Subject: Catawba Nuclear Station - York County, South Carolina  
Permit#76-2A-084  
Standby Nuclear Service Water Pond Level Increase to Elev. 574  
File: CN-702.11

Attached please find a copy of the approval letters from the Army Corp of Engineers and South Carolina Department of Health and Environmental Control for the January 25, 1996 application to raise the Standby Nuclear Service Water Pond elevation by two feet.

NO. 1124.00-00-0010

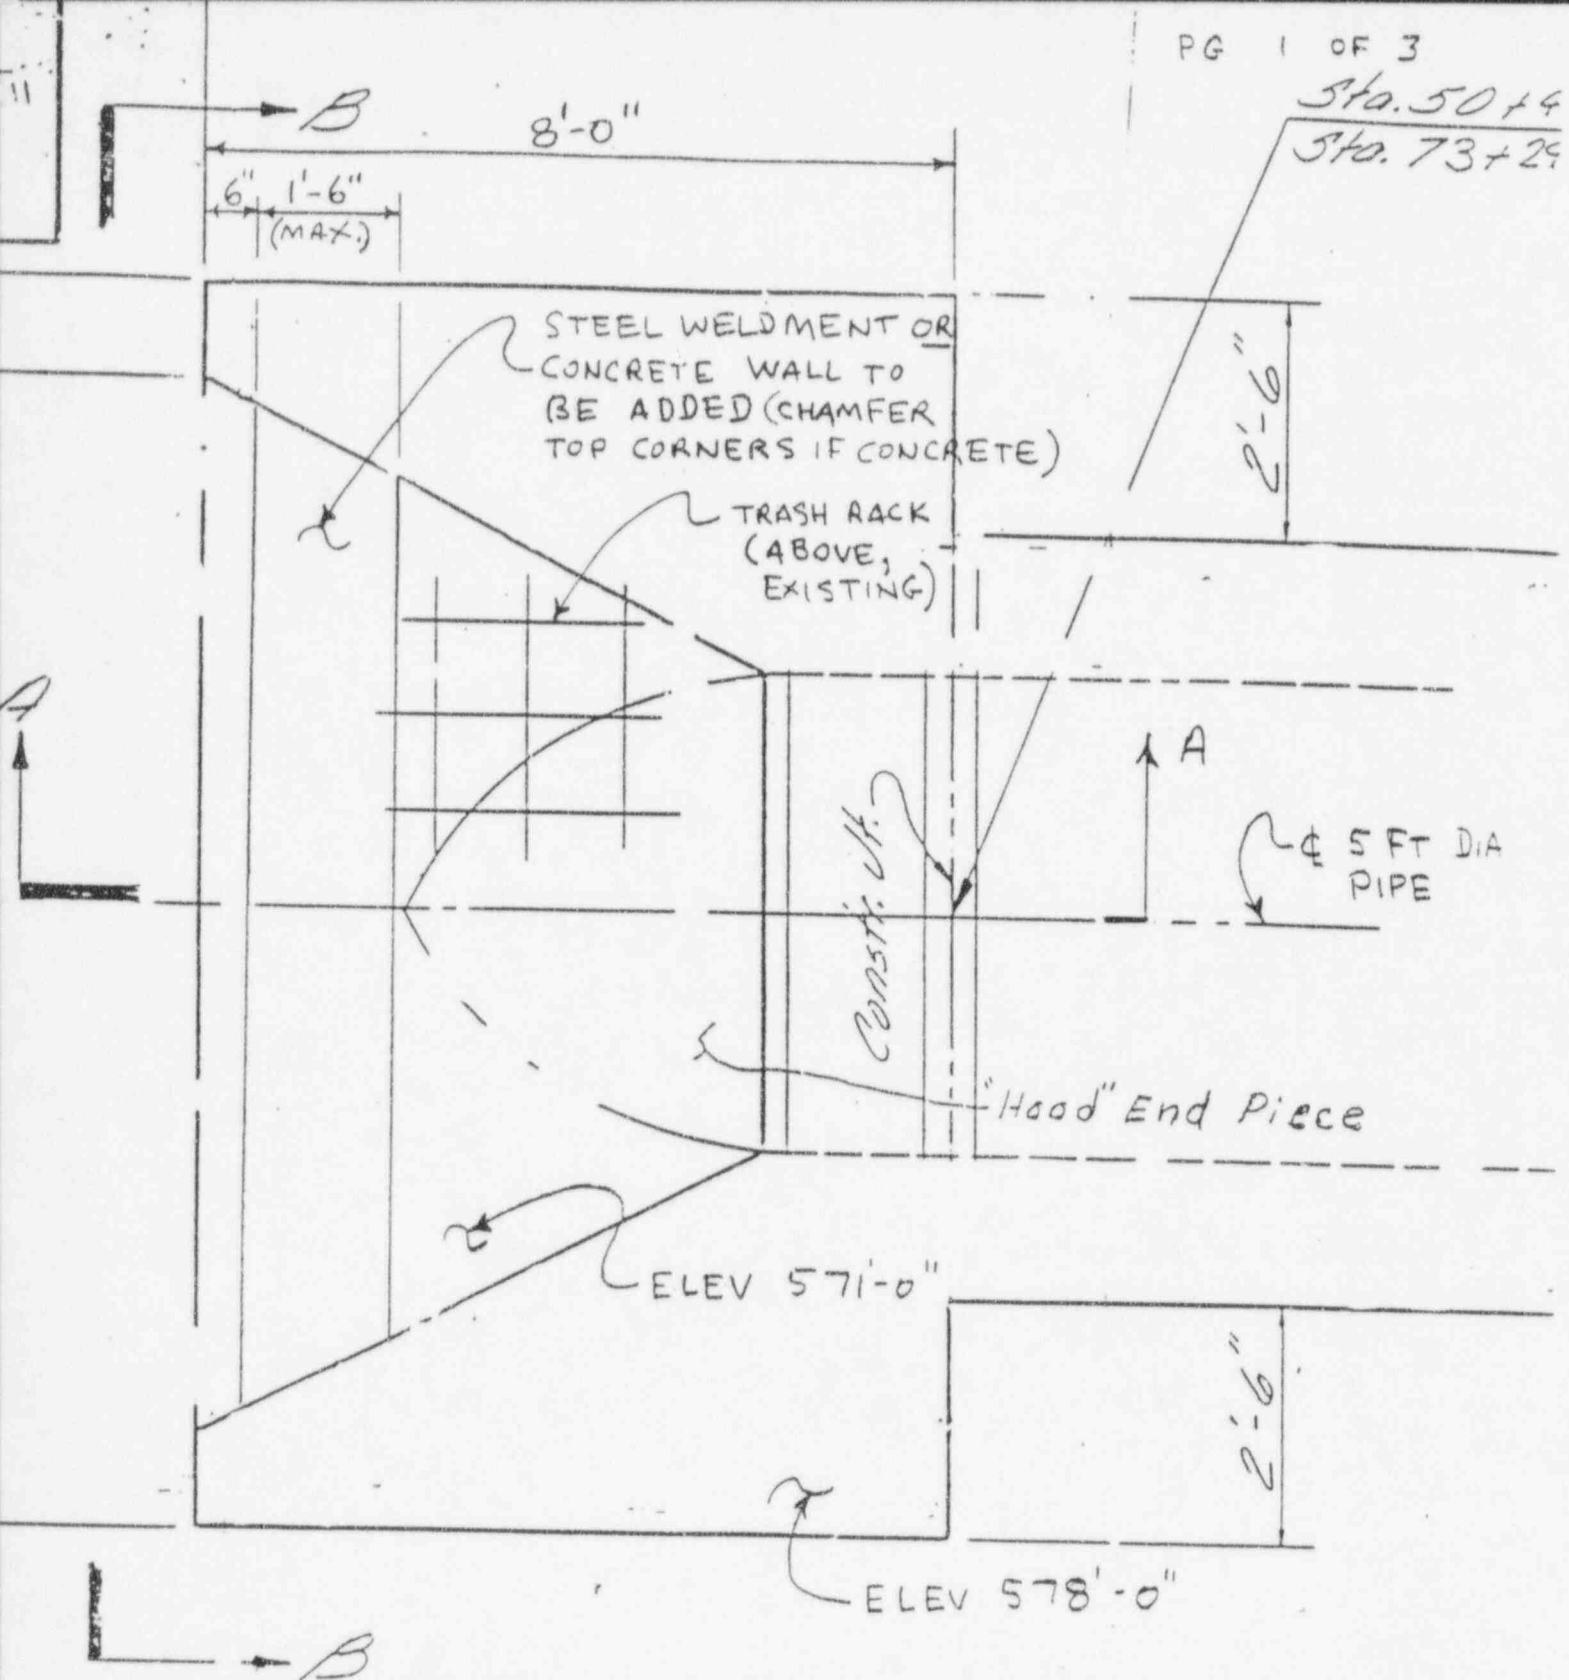
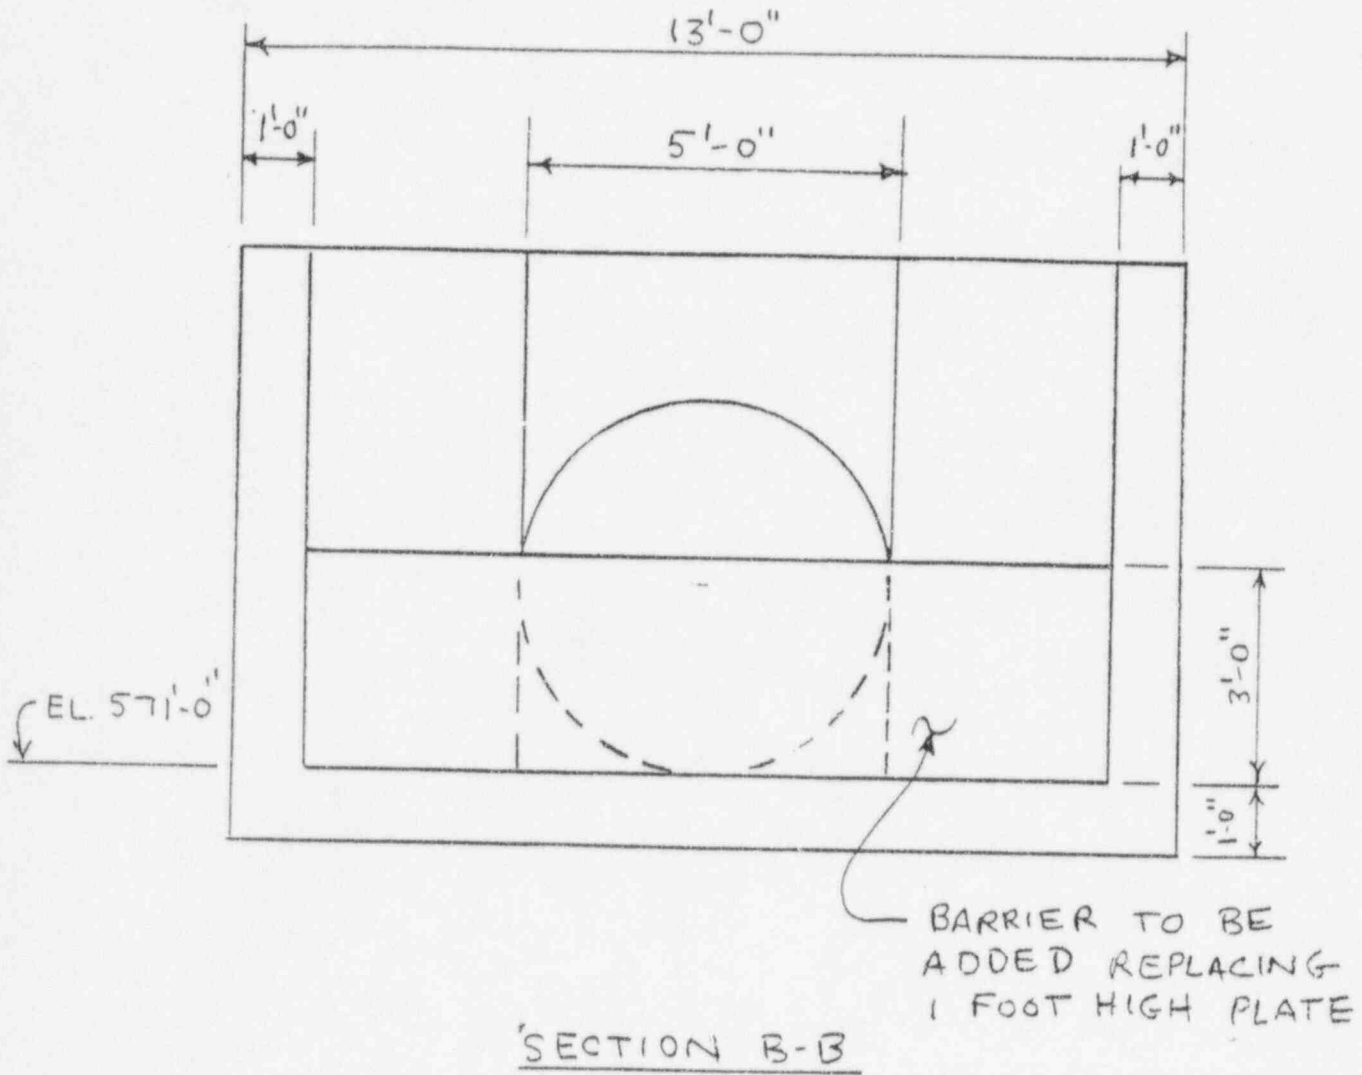
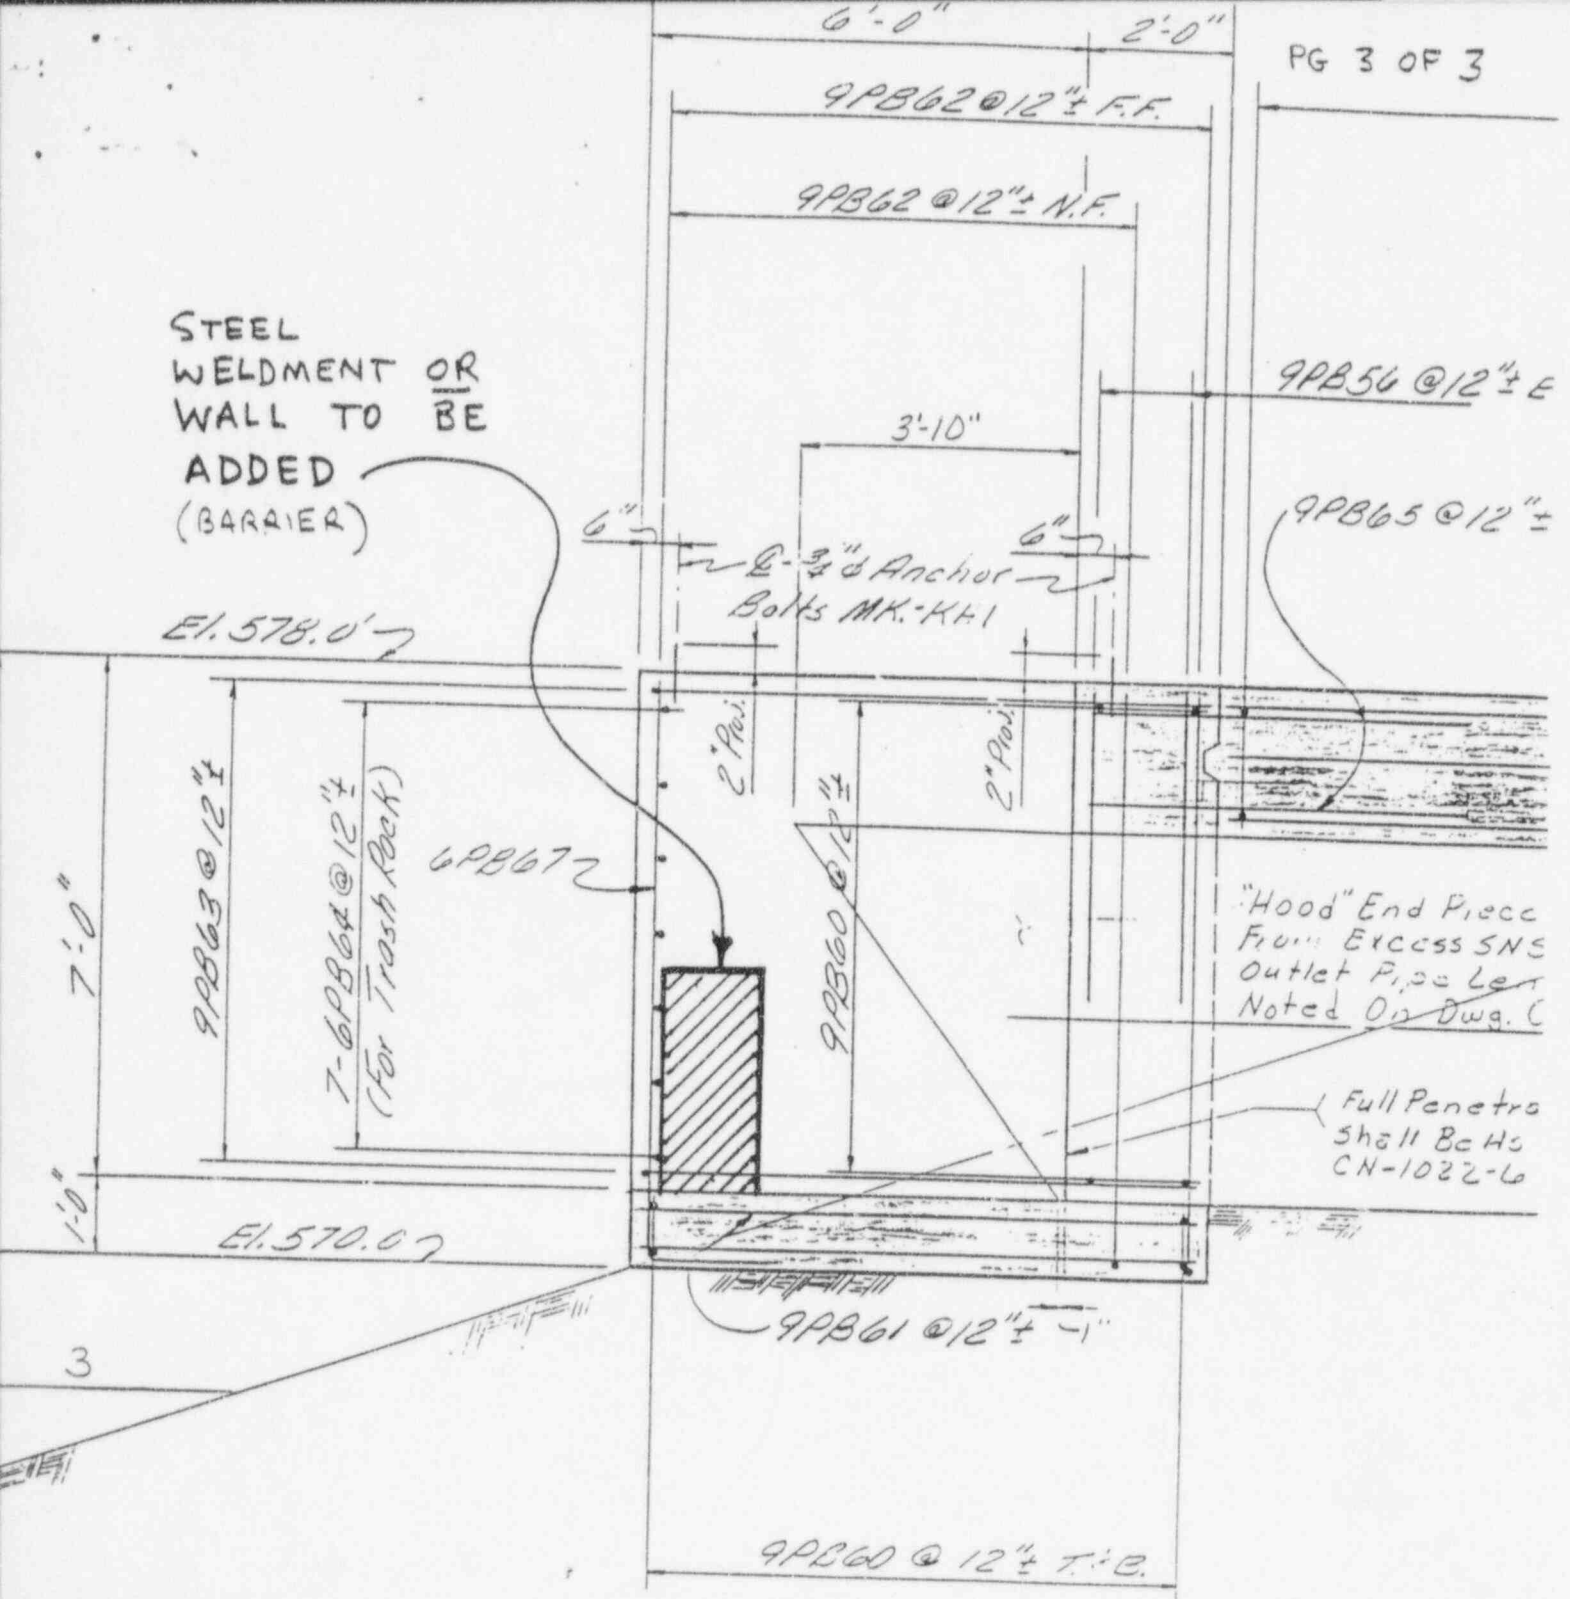
A review of our files indicates that a permit for the Catawba Nuclear Station was issued on February 22, 1977 (#76-2A-084). Therefore, this office is hereby granting a modification to that permit to reflect the change on the attached drawings (Sheets 1-3 of 3 dated January 25, 1996). This change includes the replacement of an existing 1 foot steel plate located in the discharge headwall with a 3 foot steel or concrete plate.

SNSW POND DISCHARGE HEADWALL PROPOSED MODIF.  
 REPLACE EXISTING ONE FOOT HIGH PLATE WITH  
 3 FOOT HIGH CONCRETE OR STEEL BARRIER
